No Practical Alternatives Authorization Certificate

Project Name: Summit Terrace
Project Number: WP-24-119

NO PRACTICAL ALTERNATIVES REVIEW LETTER

Re: **Summit Terrace**
Jordan Buffers No Practical Alternatives Analysis Request
Chatham County, NC
Project No. WP-24-119
SAW-2022-00935
Sage Project #2023.024

SHEET TITLE:
FINAL IMPACT OVERALL EXHIBIT
SHEET NO.:
IE-1.0

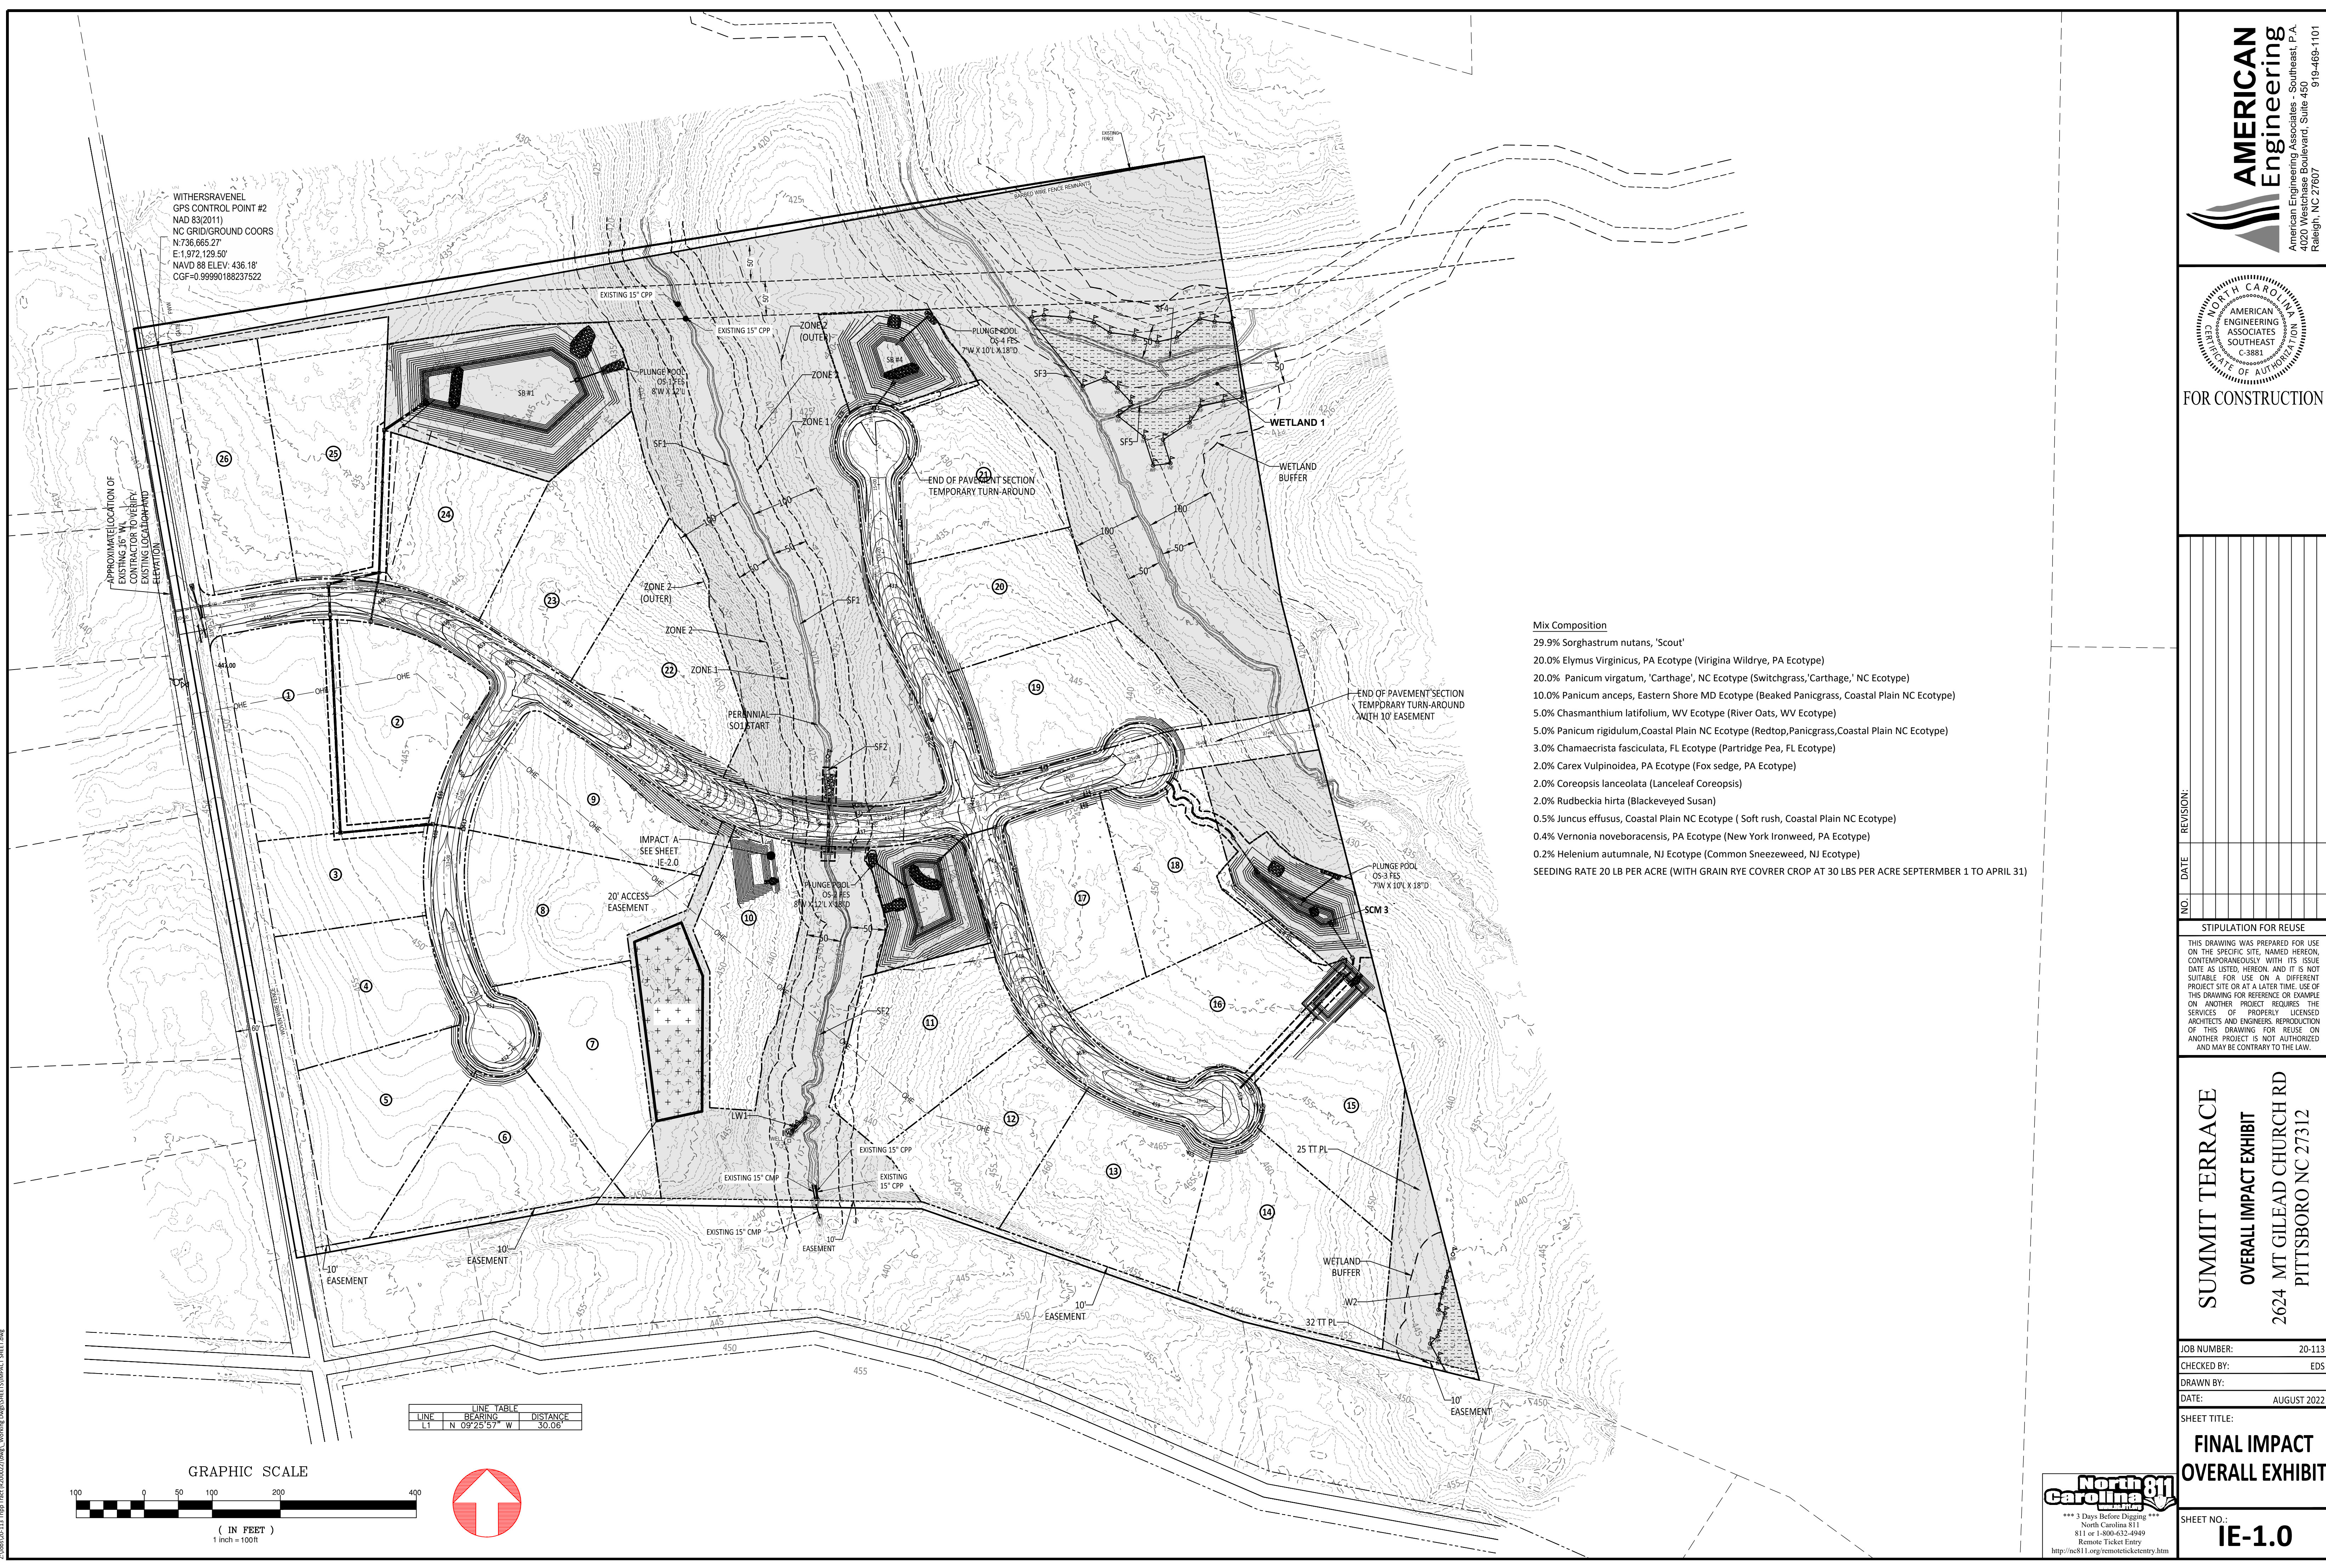
4. *It appears the perennial/intermittent transition point is labeled on IE – 1.0, that can remain, but intermittent and perennial stream segments impacted must be called out on each sheet of the buffer impact map set. Ensure stream is labeled and matches the riparian buffer review dated May, 26, 2022. These features are labeled as SF1(perennial) and SF2(Intermittent) on riparian buffer review.*

5. *Sheet IE -1.0 is labeled as overall impact, is this the final impact? If so, please update title to read – Final Impact Overall Exhibit. If not, update impact to show the temporary open water diversion/bypass channel that is on construction drawing impact map sets.*

The perennial start point has been more clearly labeled on the revised, attached maps.

The map has been updated and is attached.

SHEET NO.:
IE-3.0

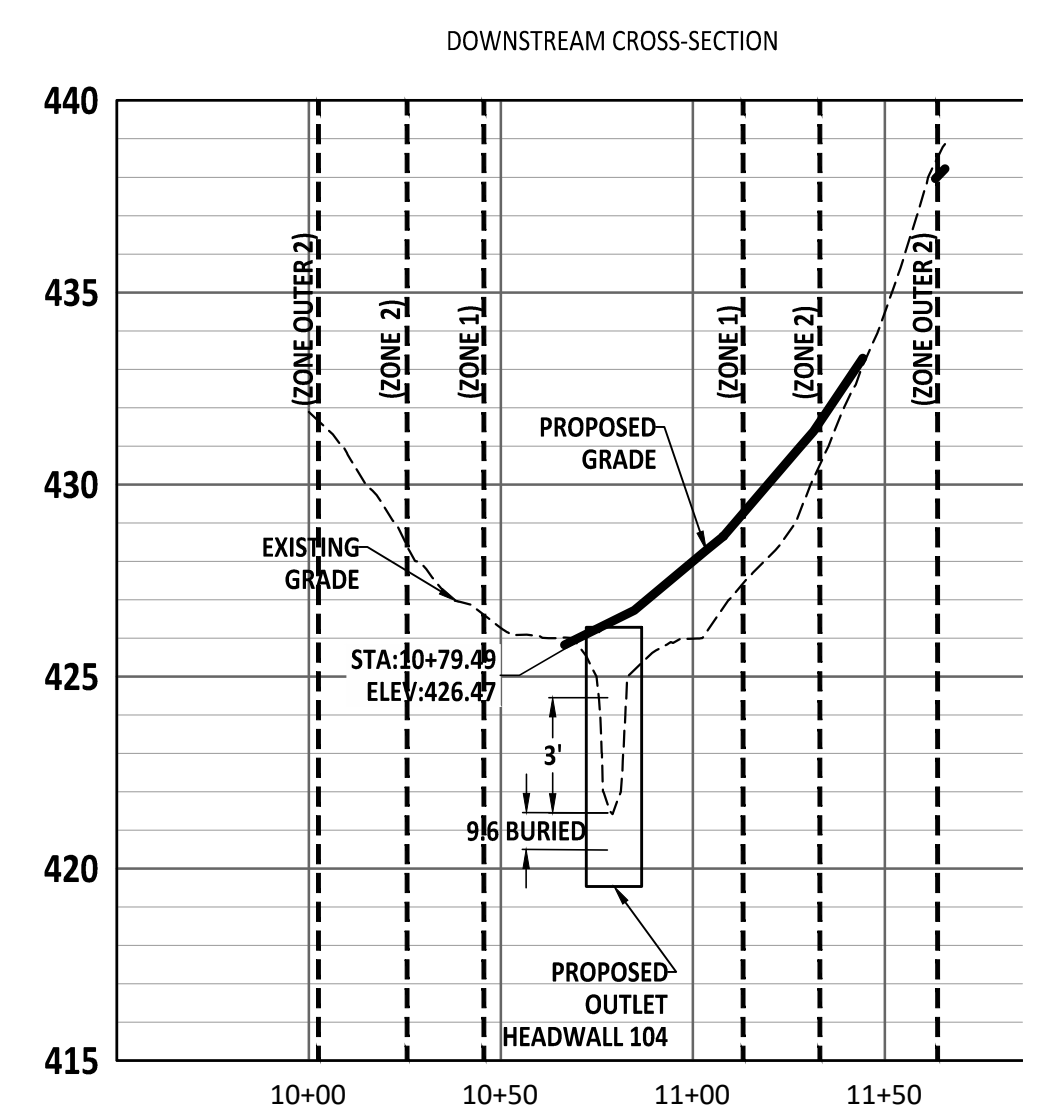
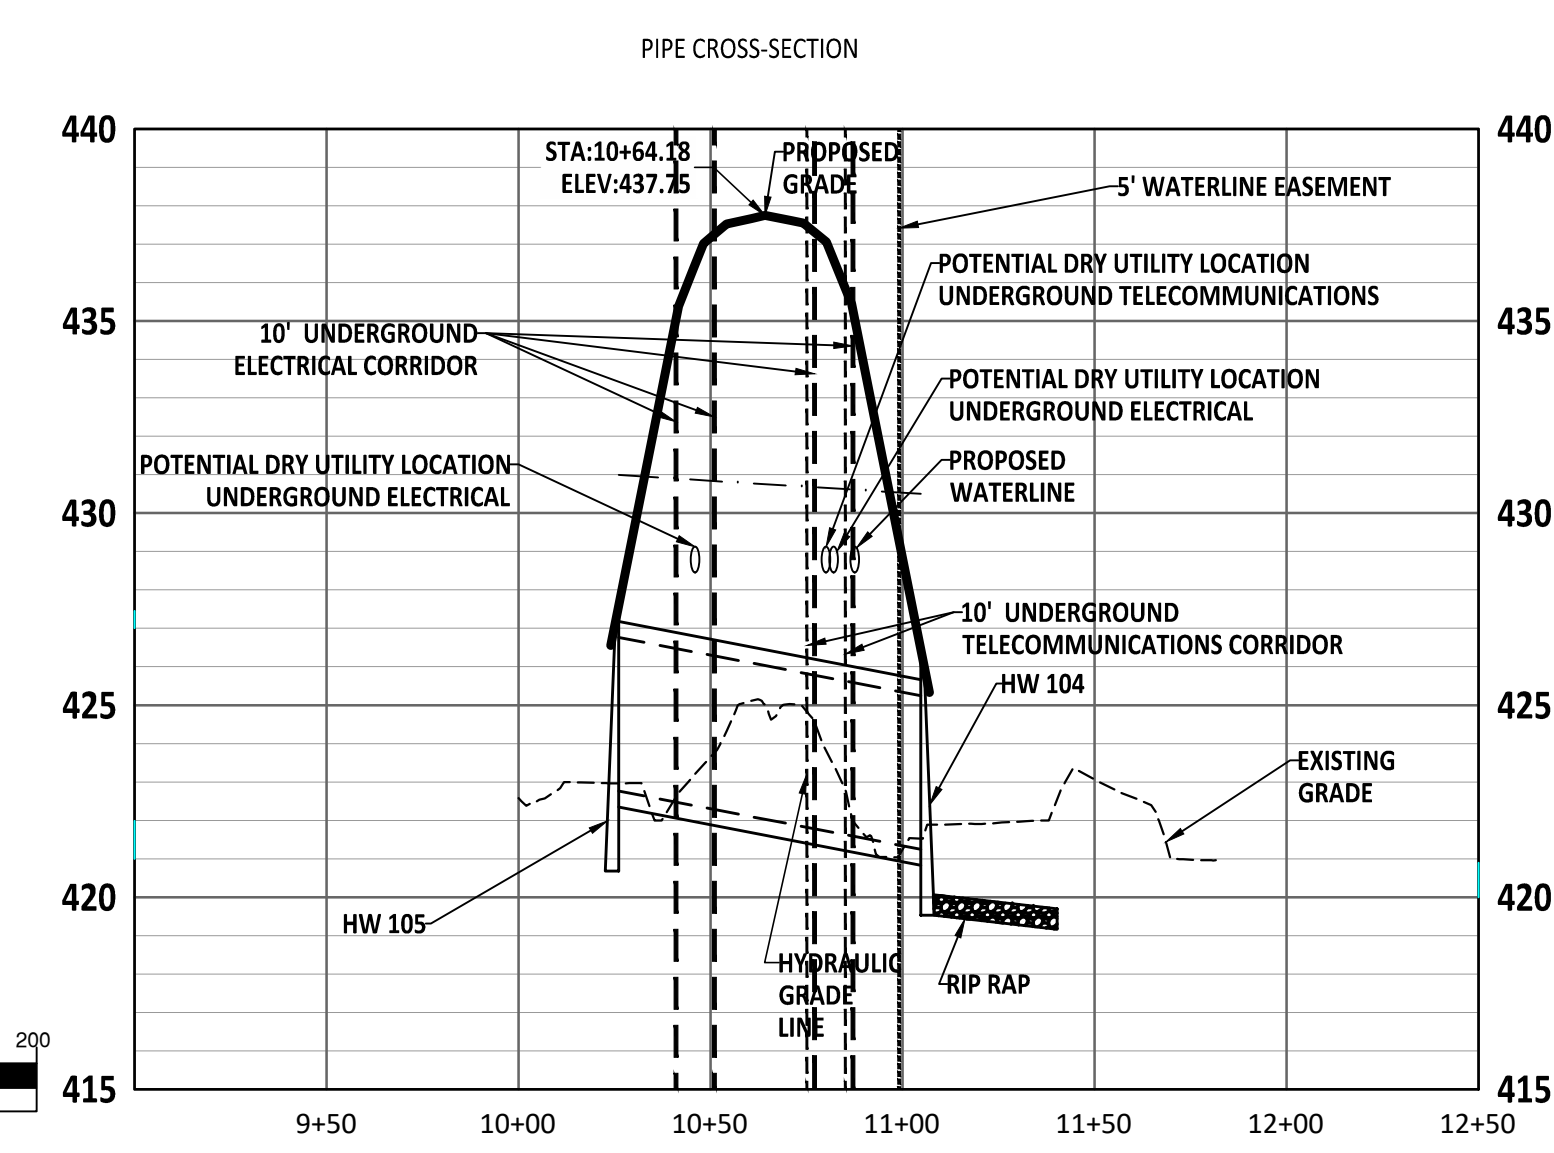
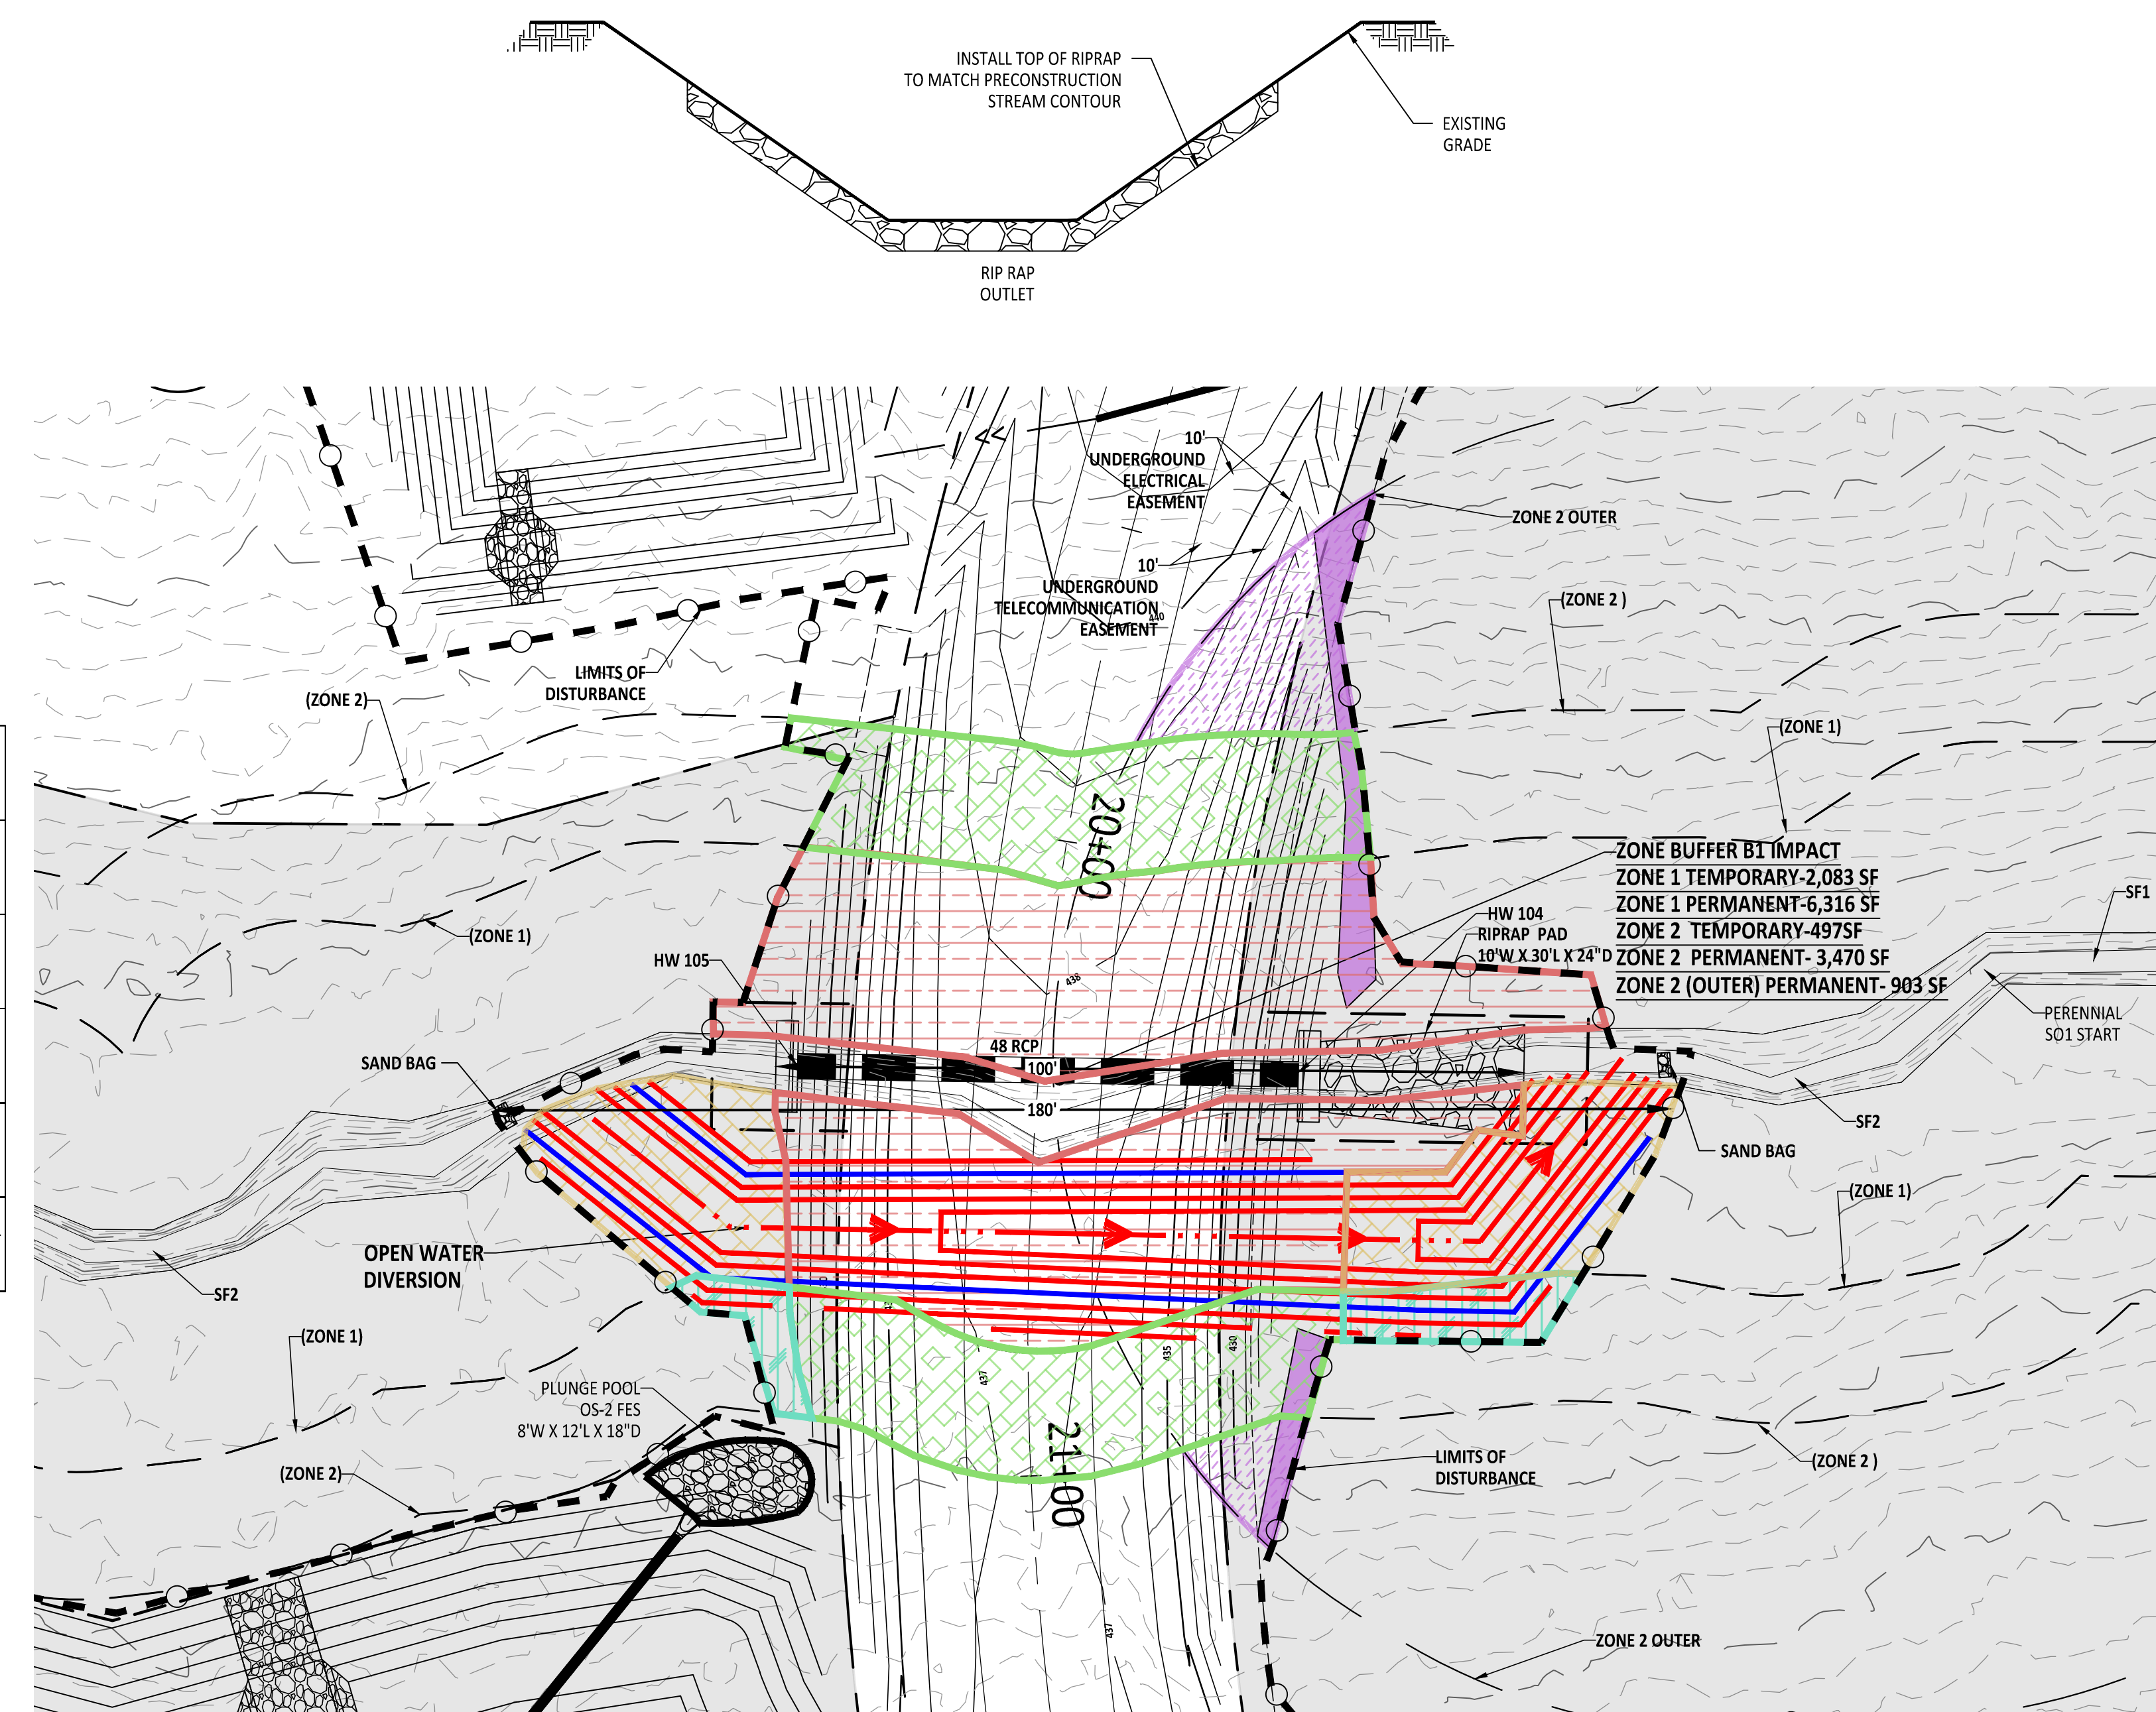
7. *Buffer impact hatching on IE – 3.0 is difficult to read. Buffer limits should be a colored line, or colored hatching. If colored hatching is chosen, ensure open water diversion/channel bypass with associated grading is still easy to read.*

The map has been updated with different symbology to depict the impact areas more clearly.
